OBJECTIONS AND COMMENTS ON DA 2023/1832

**By Robert Story and Susan Duncan, additional to Helen Monks,
Town Planner**

5 PORTIONS, LOVETT BAY NSW

DRG-01
LEPLASTRIER HOUSE
NEIGHBOUR INTERACTION

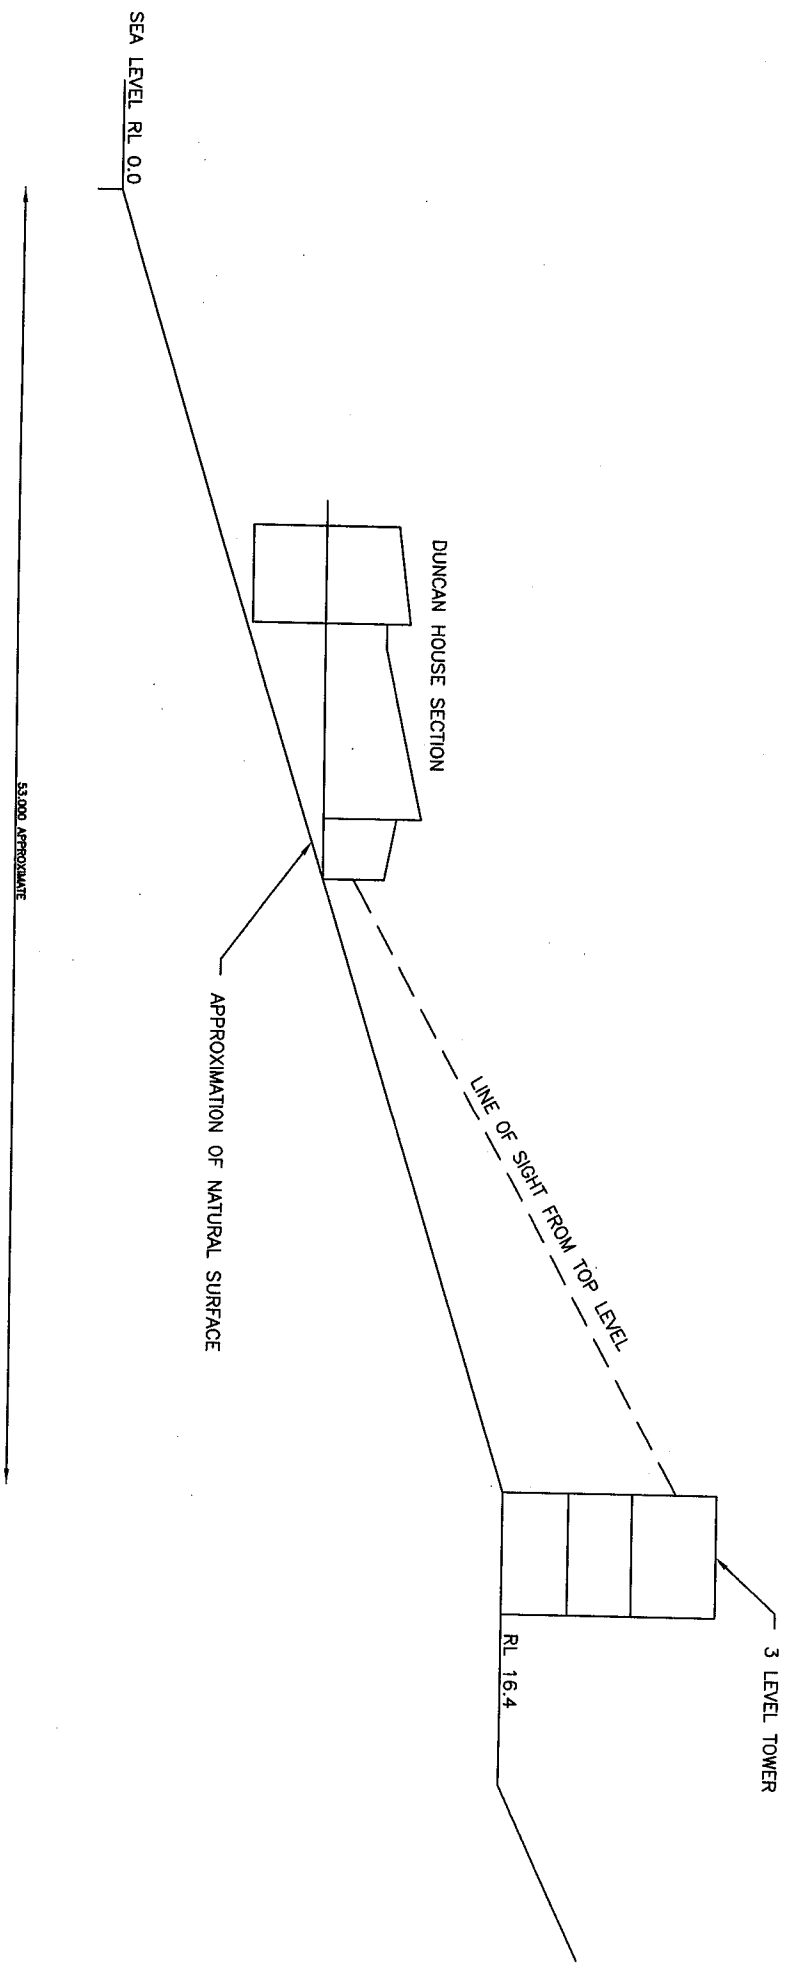
2.7 Exposure: Steep terrain (45 degrees) above Lot 5 means there is virtually no sun in winter (see drawing DRG-01). The absorption trench would be shadowed by the house for more than six months of the year. This makes 2.7.1 site exposure limitations moderate.

2.8 Slope: The average slope from seashore to the back of Lot 5 building area is approximately 20 degrees which makes Lot 3 and Lot 6 vulnerable to significant leakage of the proposed absorption trench. Refer to drawing DRG 01 for trench location.

Figure 3.1: Profile Cross-section south to north (site building envelope in blue)

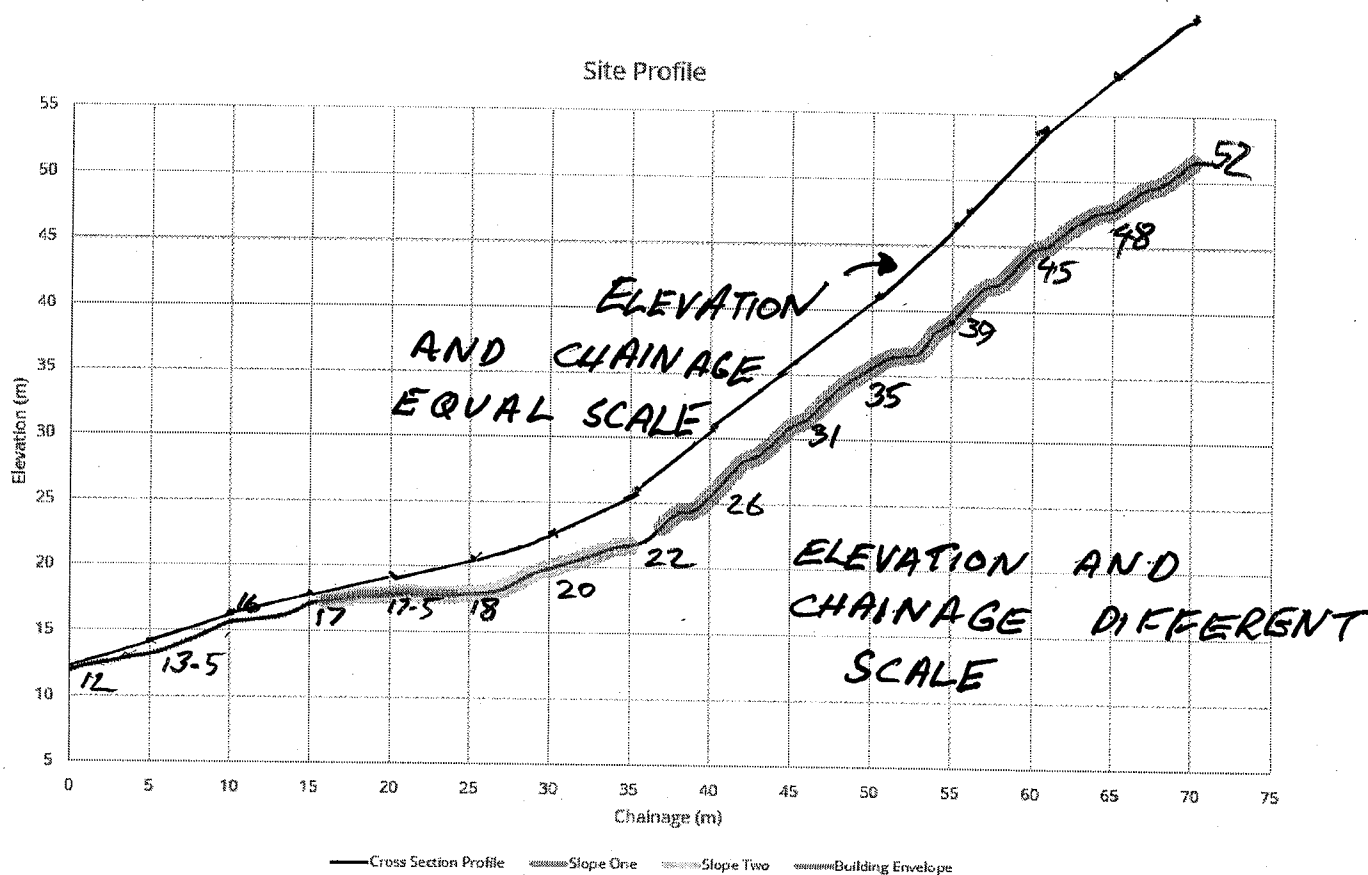
Figure 3.1 profile cross-section is misleading. The elevation and chainage are different scales, giving a shallower appearance of the slope of the land.

Refer to DRG-04 The block is steeply sloping from the water's edge, starting at 20 degrees and increasing to 45 degrees.

There are several horizontal benches or terraces cut into this slope but they do not affect the overall steepness of the block.

DRG-05 BOUNDARY ERROR
APPENDIX A

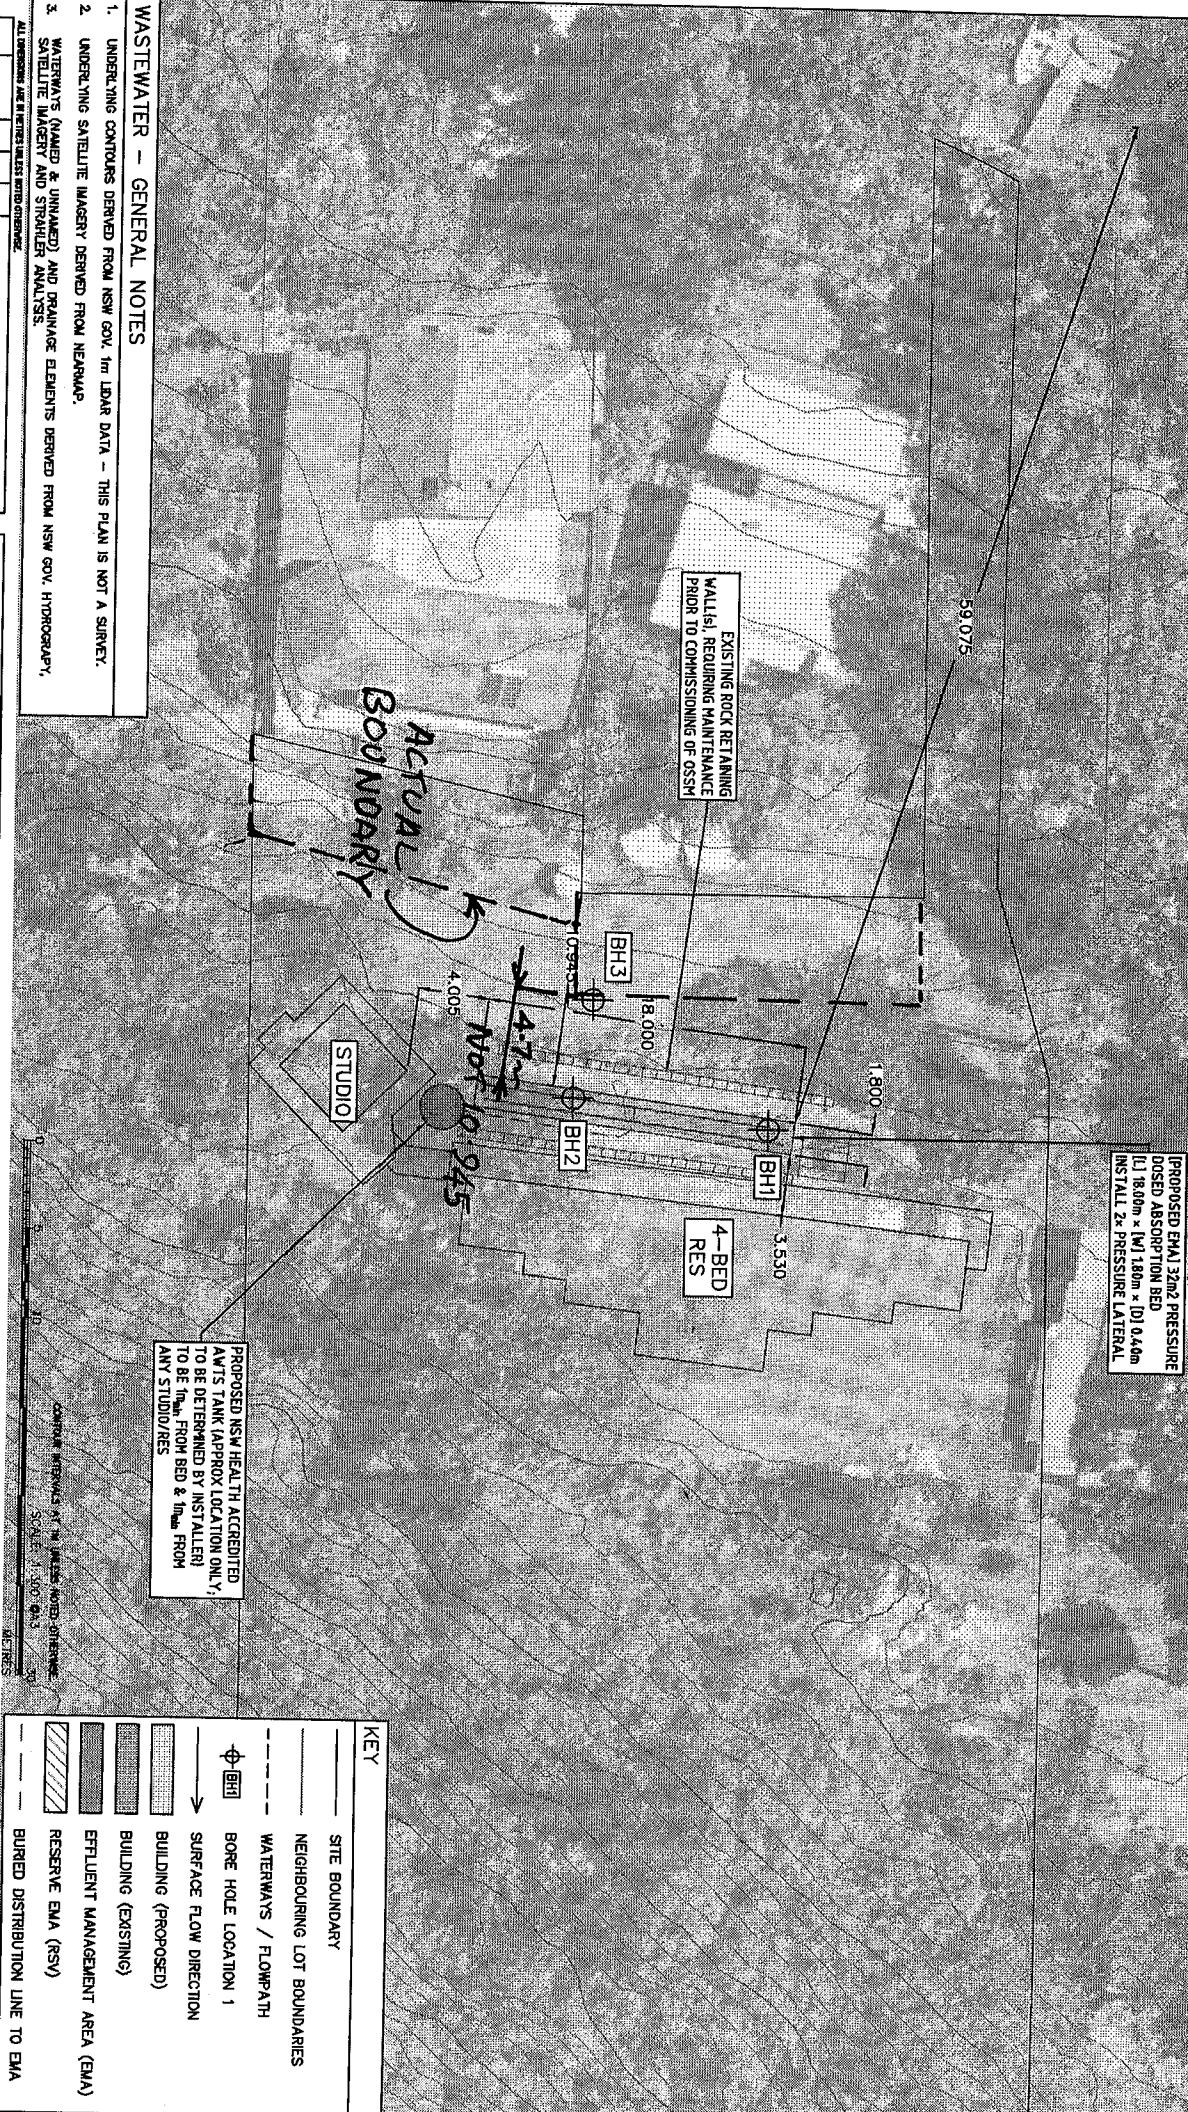
E Position of land application area in landscape: boundaries are incorrectly shown on Appendix 1 and are out by a distance of **7 meters**.

Appendix 1: Boundaries of Lot 3 and Lot 6 incorrectly drawn and show a major discrepancy of 7 meters. See drawings 5 & 6.

1. EMA is far too close to 3 Portions boundary and must be located at least 12 meters off this boundary.
2. Appendix 1 of the wastewater report shows the Portion 3 property boundary to be approximately 7 metres south of the actual location.

DRG-07 SHADOW LINE

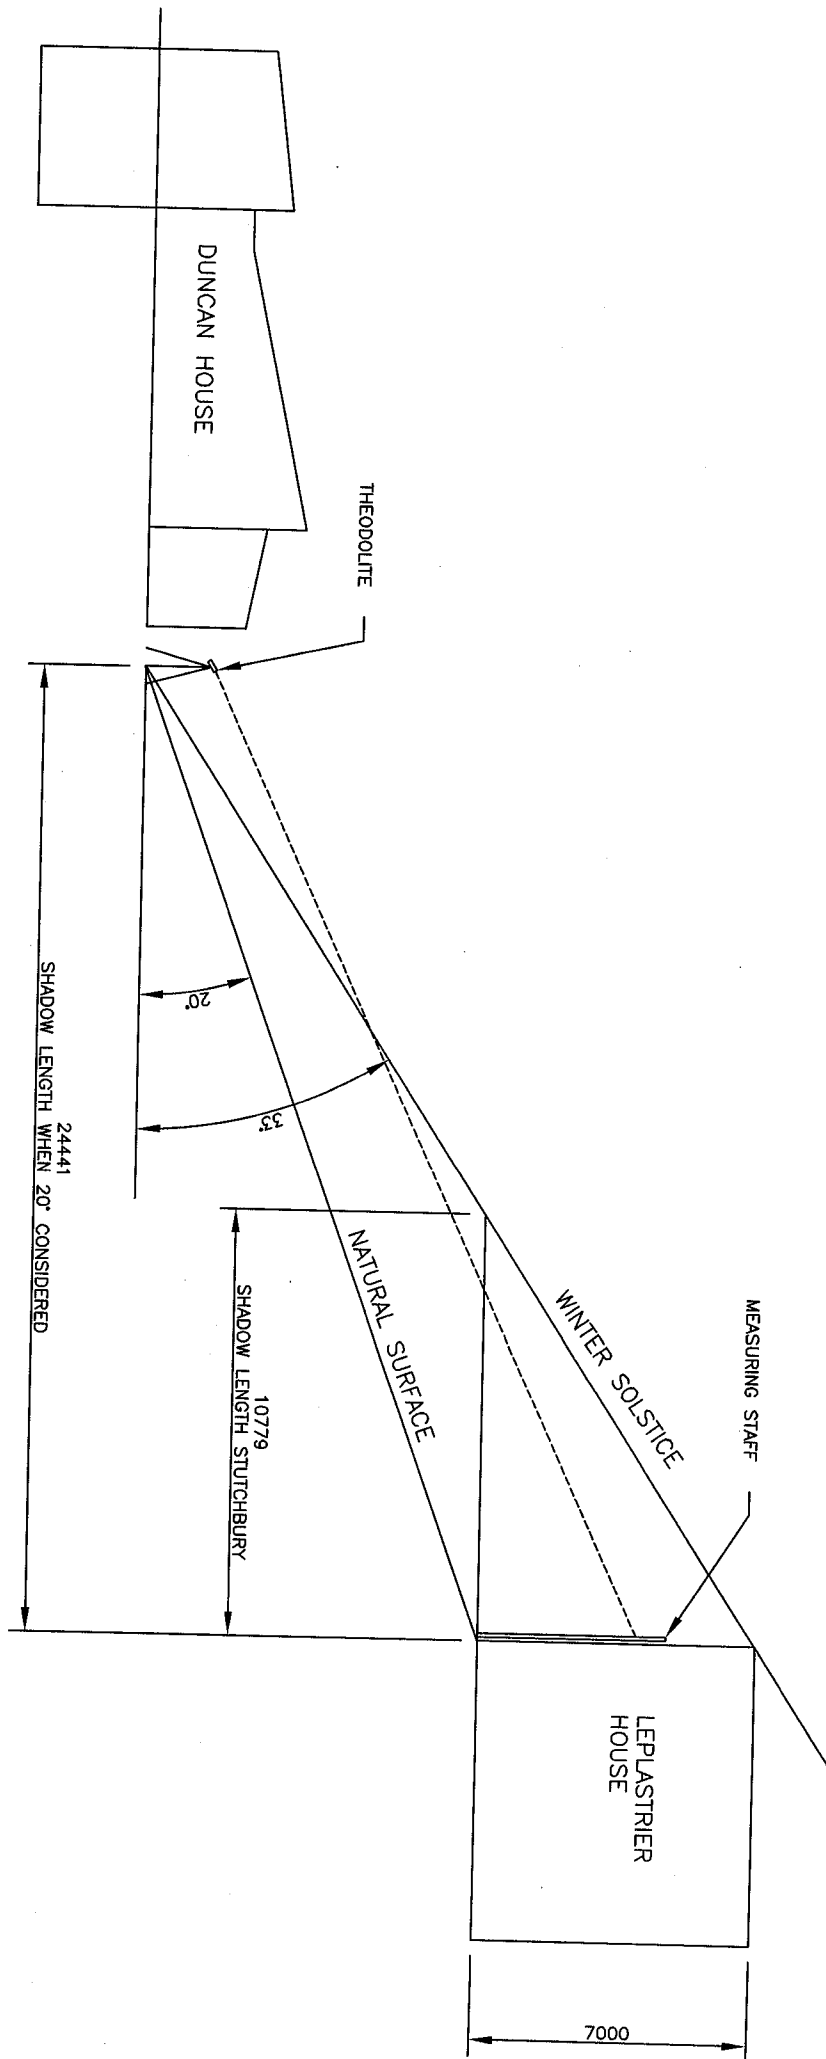
There is a fundamental error in the shadow lines provided. *See DRG 01, 07,08.*

Analysis does not take into account that the land between 5 Portions and 3 Portions, falls steeply away at around 20 degrees. The shadow lines chase the sloping land until the shadow line catches up. Shadow length is around 11 metres, whereas I have calculated a shadow of approximately 25 metres. **See DRG 07.**

We can argue the correct shadow length, but the simplest solution is to carry out a site measurement. A theodolite can be set up at the Duncan House to sight a measuring staff at the Leplastrier designed building at the front elevation. Knowing the distance and the angle, an accurate drawing can be compiled. **See DRG -07.** No surveyor is required as I have a theodolite and can do a full and accurate check with a representative of the Leplastrier family.

DRG-08

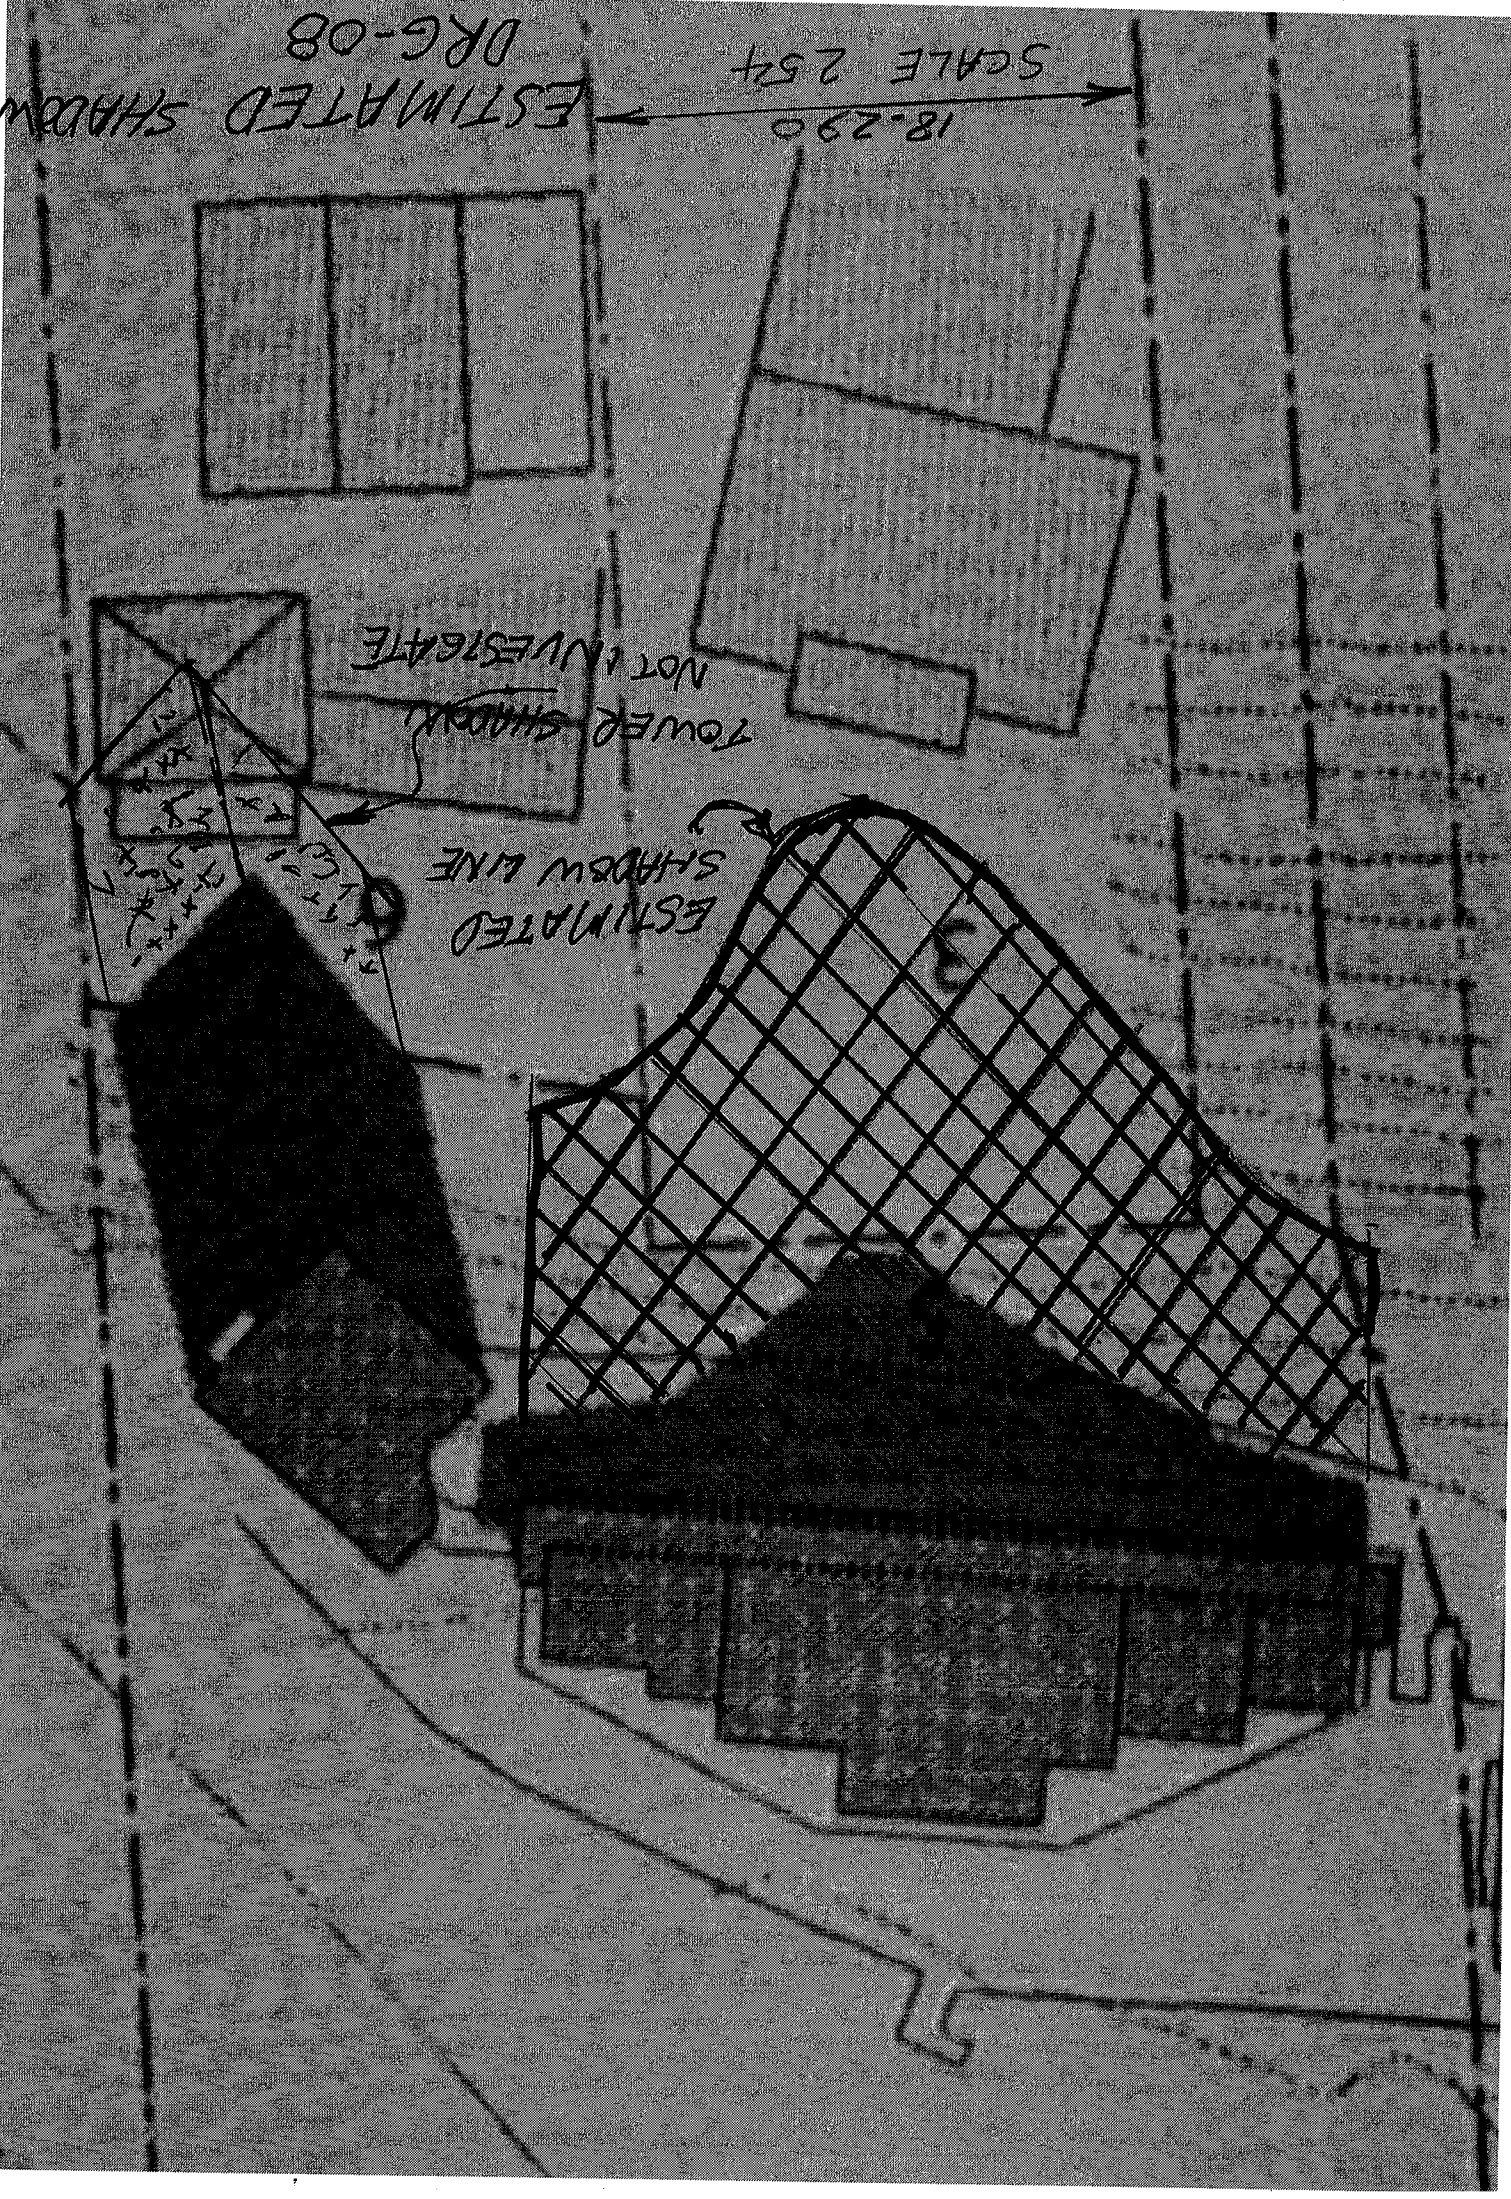
3. 5 Portions site is subject to high moisture content especially in heavy rains resulting in intermittent and semi-permanent springs.
4. Geotech report misrepresents the steepness of the site and the problems with water run-off.
5. Shadow lines are grossly understated and need to be reinvestigated. The shadow of the house would come to the back door of 3 Portions, which means that main building and the tower would dominate the view from that position.
